2012 IOAP Project Modification

IOAP Programmatic Modification Summary

August 17, 2012 (Revised September 20, 2012)

Subject: 13th Street and Rowan Street Storage Basin
Minor Project Modification
IOAP Project No. L_OR_MF_155_M_09B_B_B_4
DOJ Case No. 90-5-1-1-08254

Integrated Overflow Abatement Plan
Vol. 2 - Final CSO Long Term Control Plan
South Fork Beargrass Creek
SolutionID # L_SO_MF_097_M_09B_B_D_8
Calvary / Creekside Storage Basin

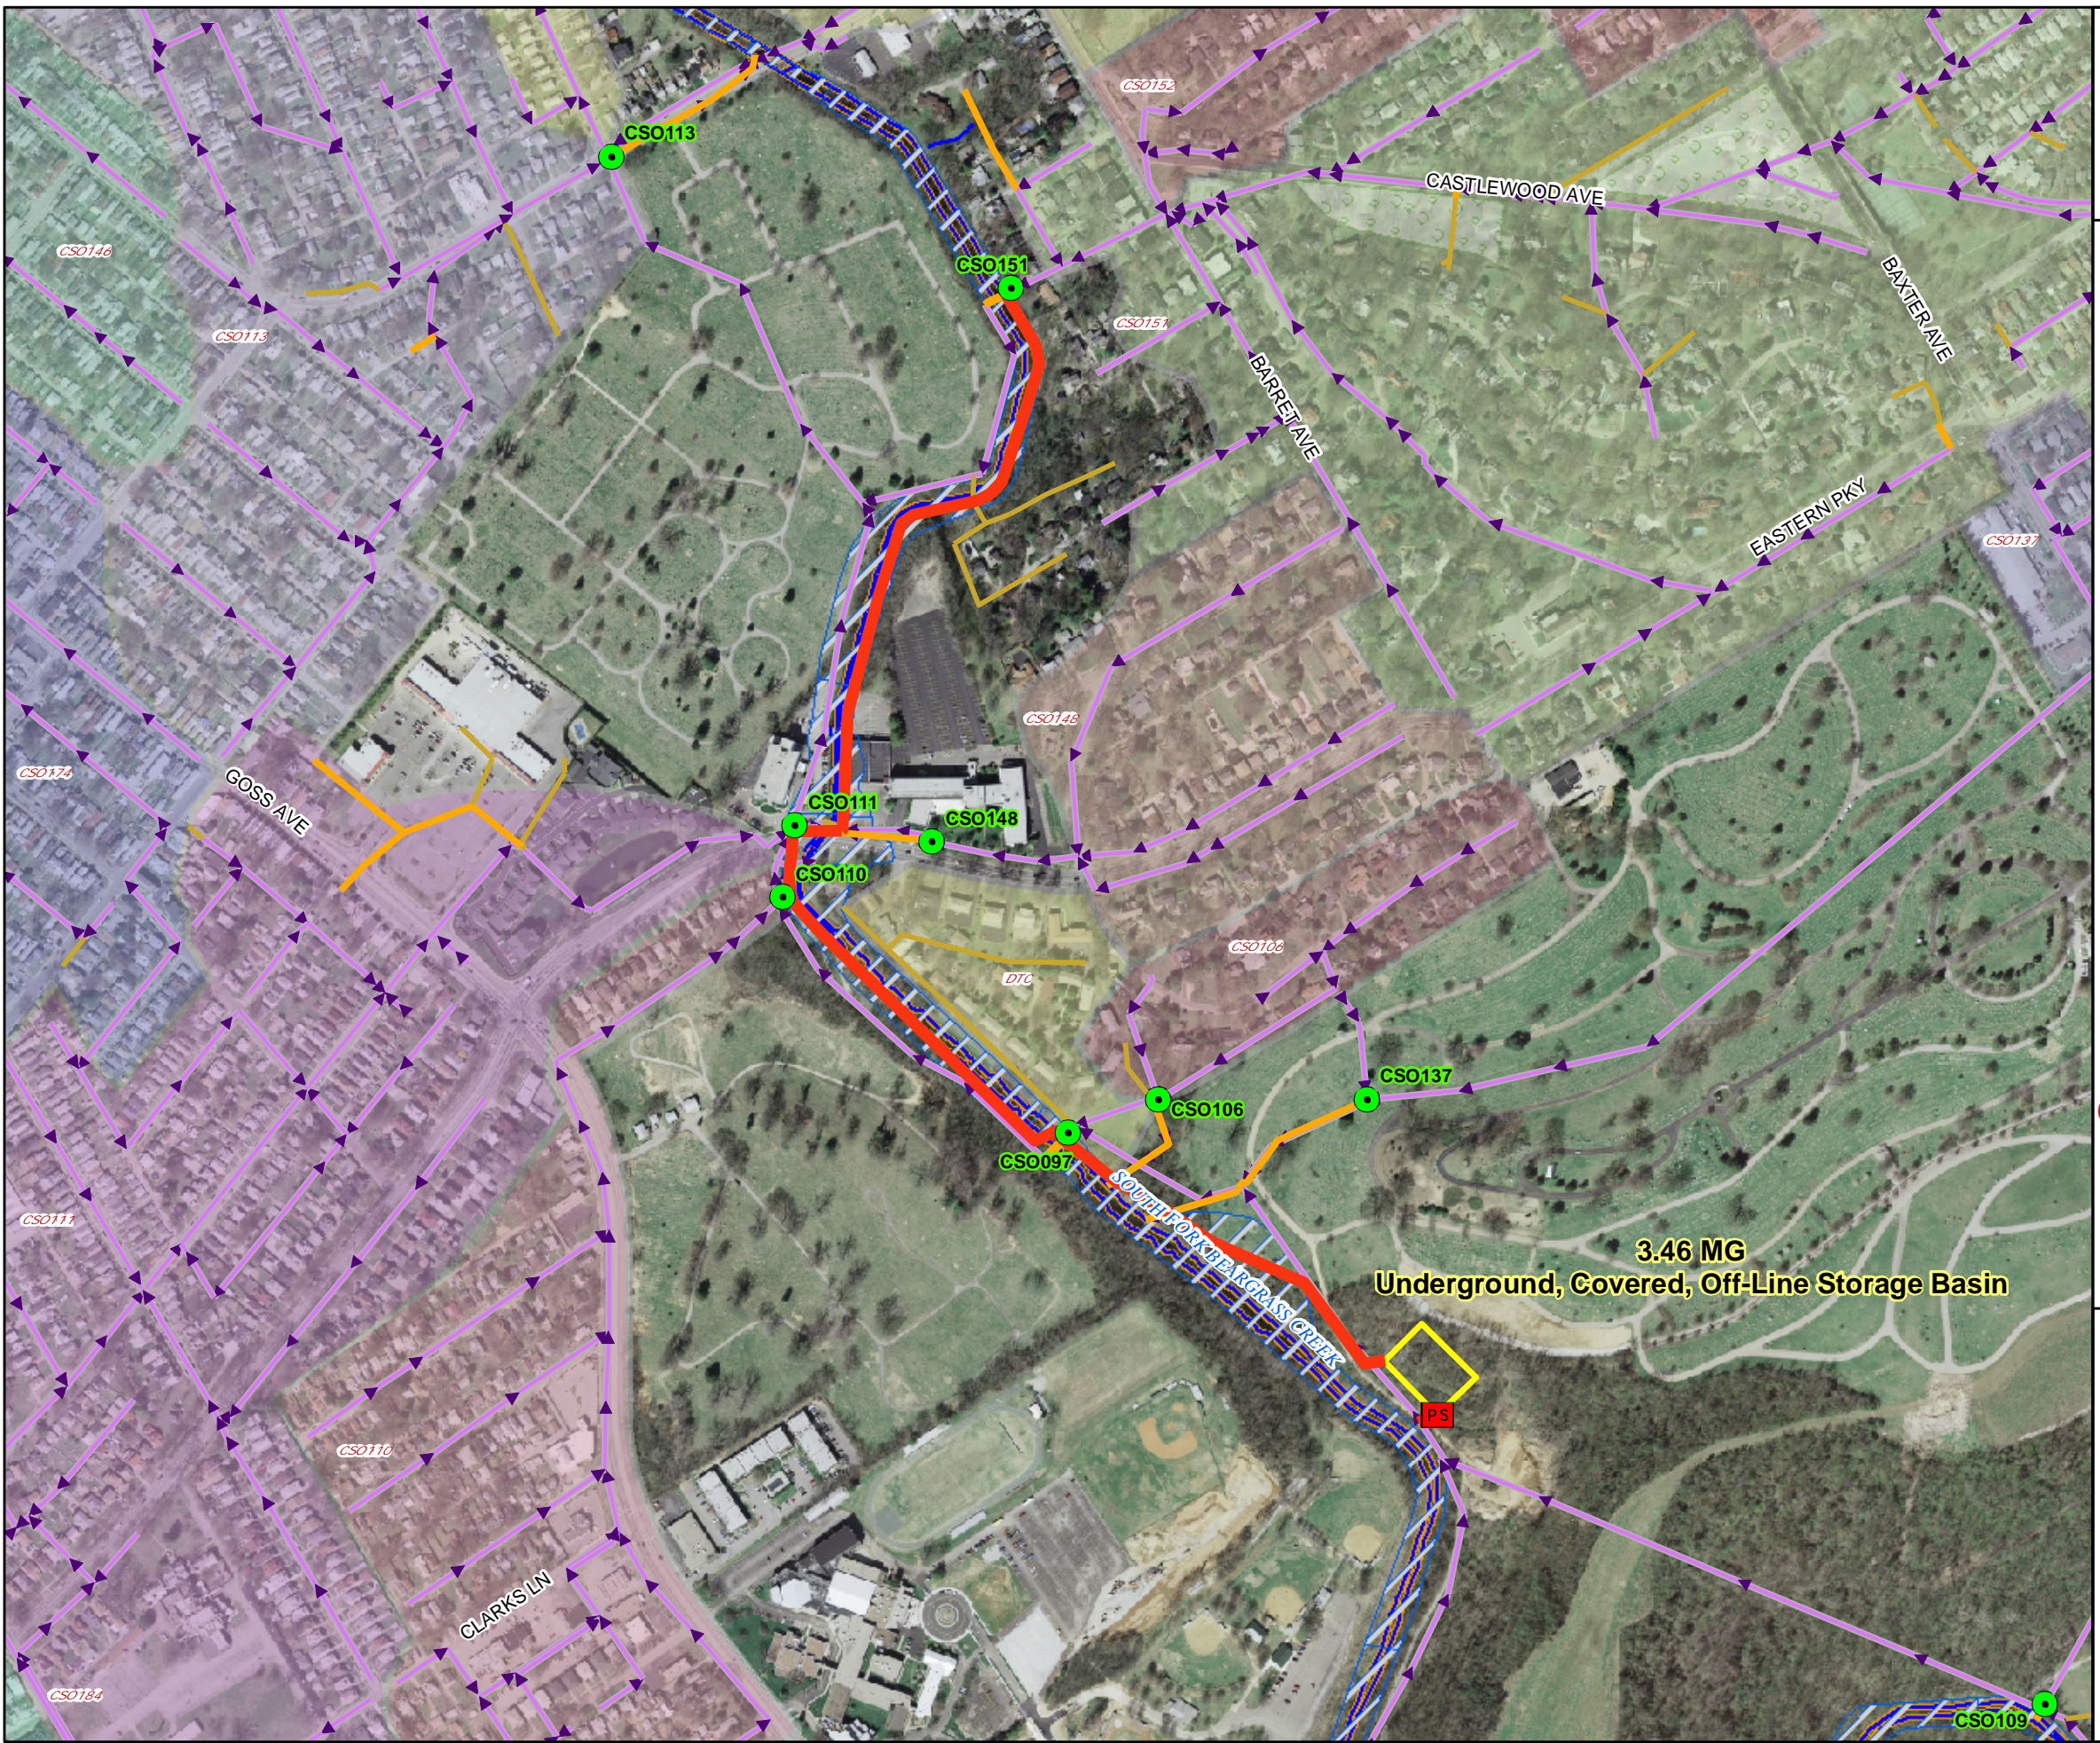
The project modification involves the elimination of this project, as other proposed project changes related to the Nightingale Pump Station and the proposed Logan Street and Breckenridge Street Basin have made the basin unnecessary.

Integrated Overflow Abatement Plan
Vol. 3 - Sanitary Sewer Discharge Plan
Combined Sewer System
Camp Taylor System Improvements

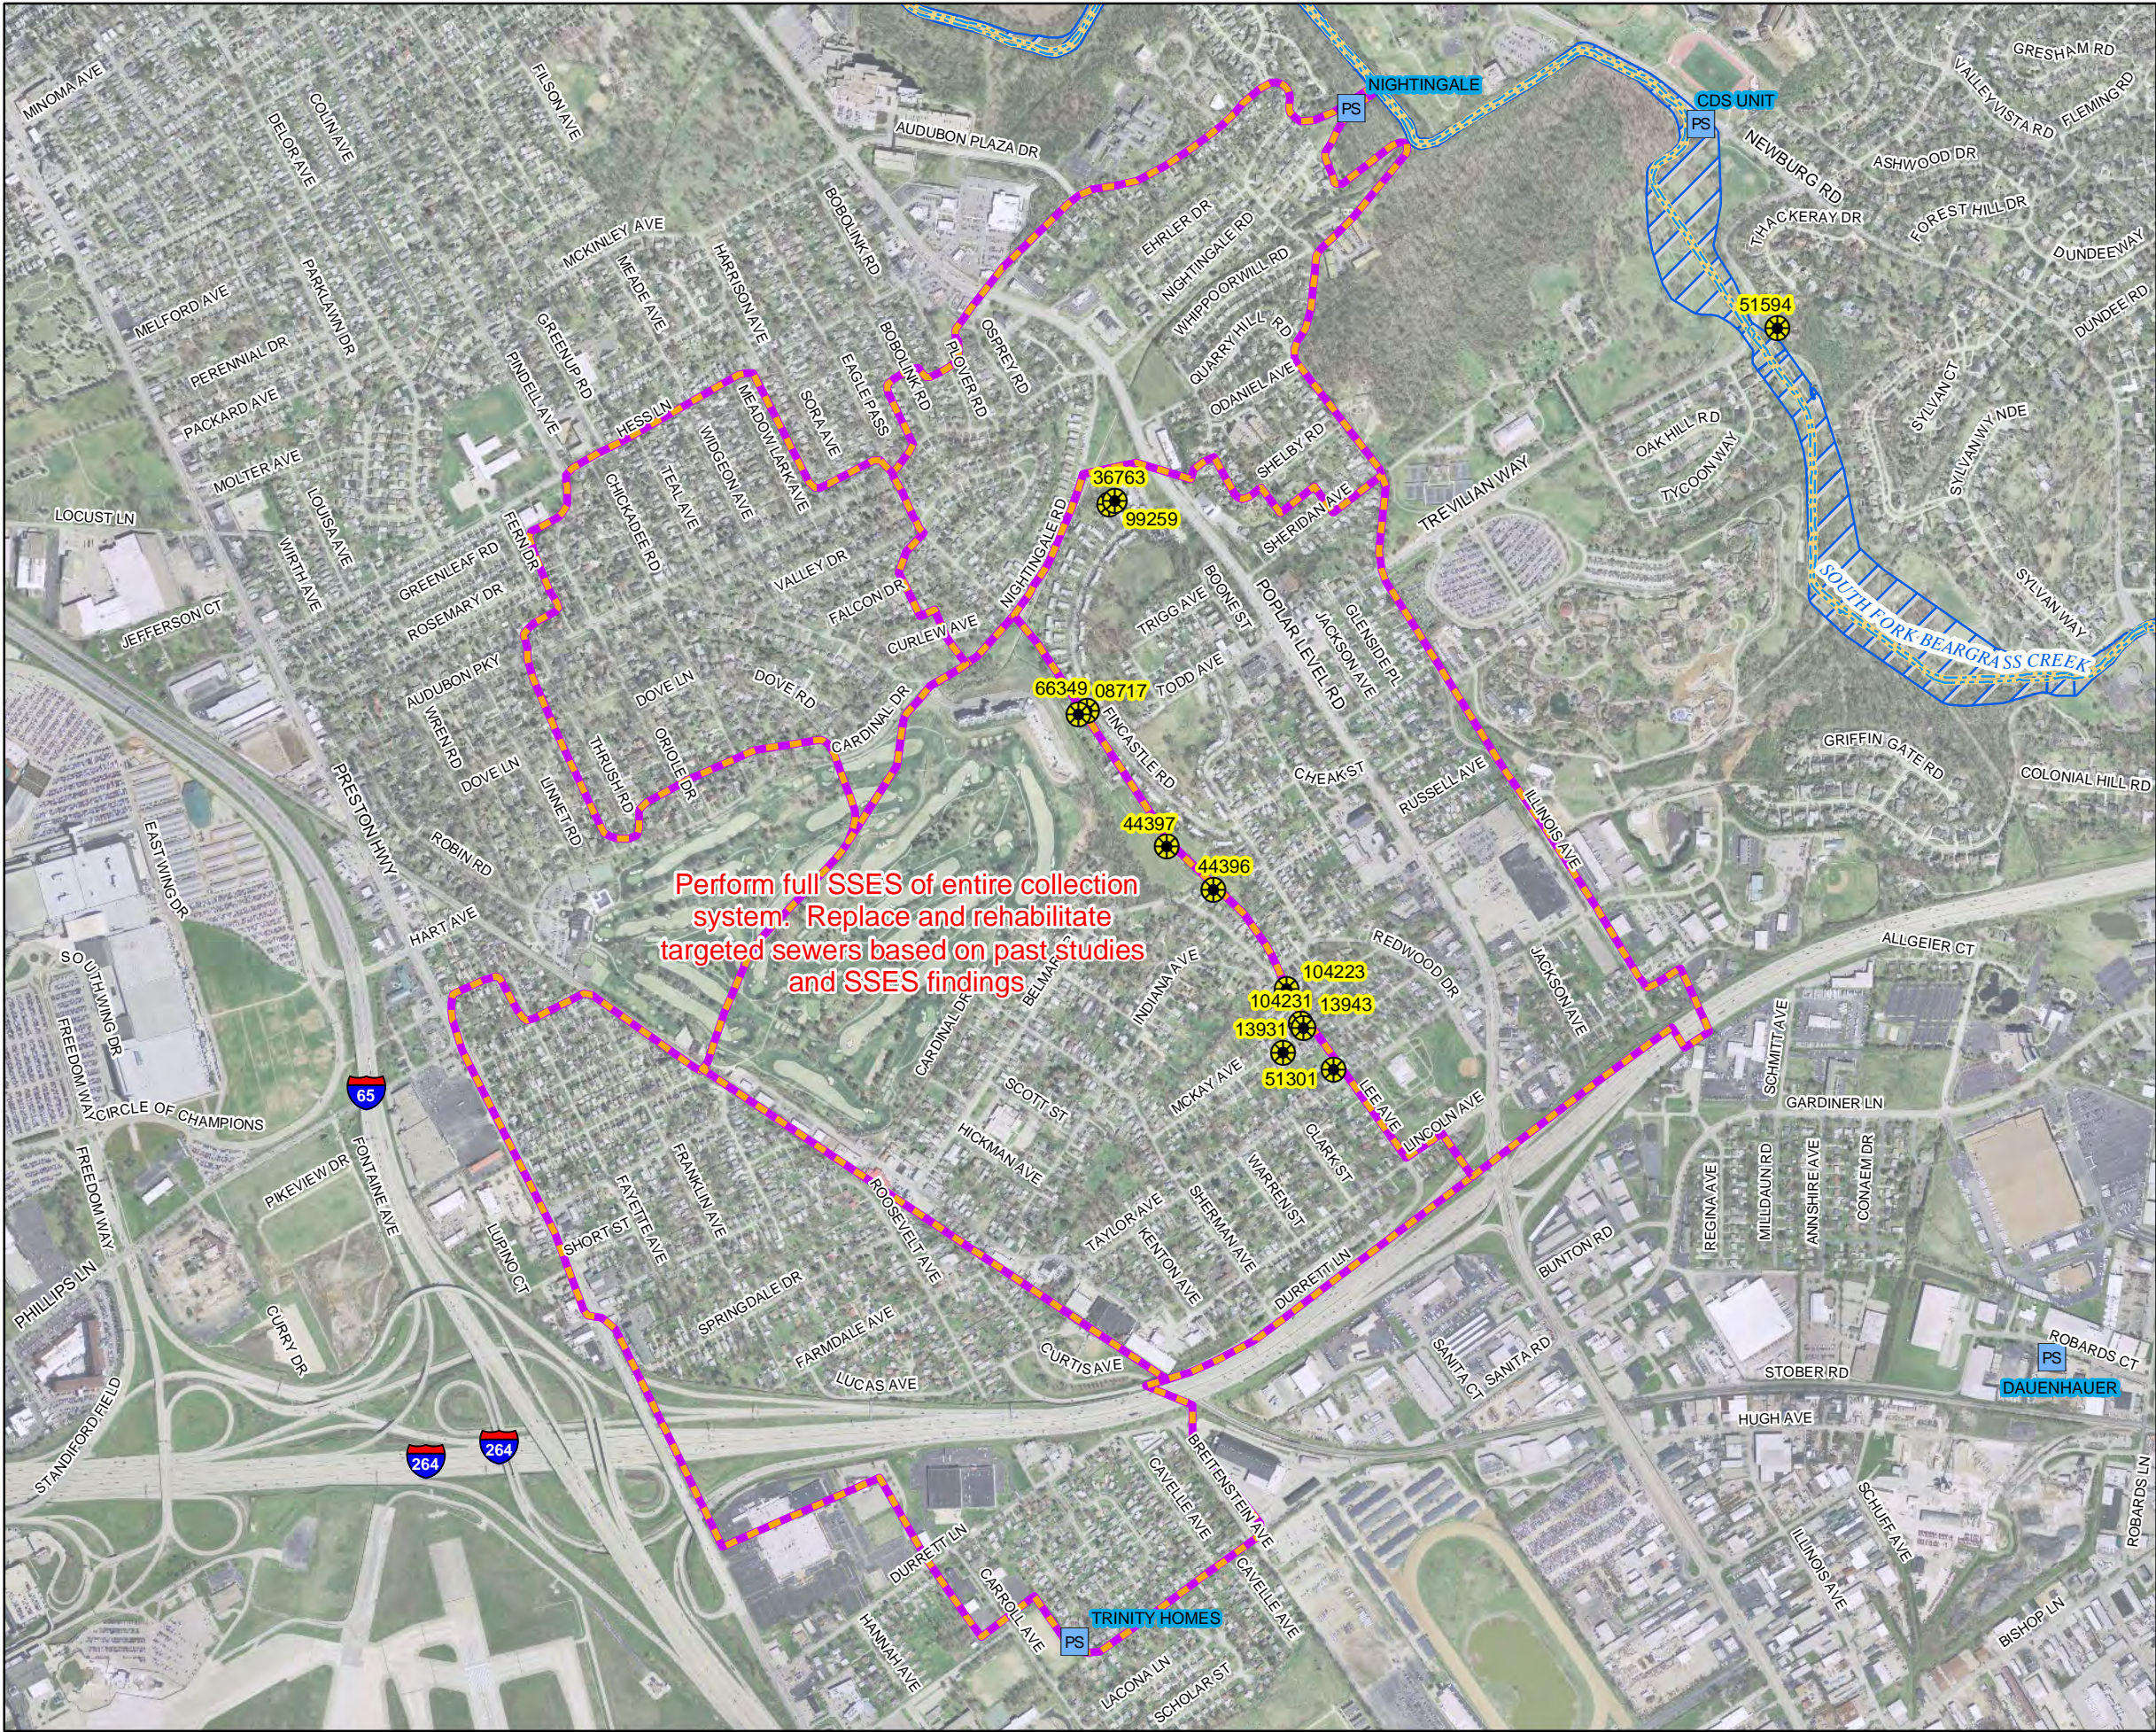
The modification requested involves the combination of the previous Phase 2 and 3 Sewer Replacement and Rehabilitation projects and the expansion of the project area. A full sanitary sewer evaluation study (SSES) for Camp Taylor and surrounding contributing sewer service area was completed in July 2011 and significant sewer defects were identified. For the SSES and this project, the project area was expanded to include Camp Taylor and the surrounding neighborhood connected to the Camp Taylor Interceptor. The new project area includes approximately 144,000 linear feet (LF) of sanitary sewer. Areas 1 and 2 represent the City of Camp Taylor and the original IOAP project area. The SSES recommended full replacement of approximately 53,400 LF of sewer and rehabilitation of approximately 29,000 LF.

<u>2012 IOAP Project Suite</u>	<u>2012 Completion Date</u>	<u>Status</u>
Camp Taylor #1 - SSES	December 31, 2011	Completed, July 2011
Camp Taylor #2 & #3 – Replace & Rehabilitate Sewers	December 31, 2017	Design/Construction
Camp Taylor #4 –Off Line Storage	December 31, 2023	Planning
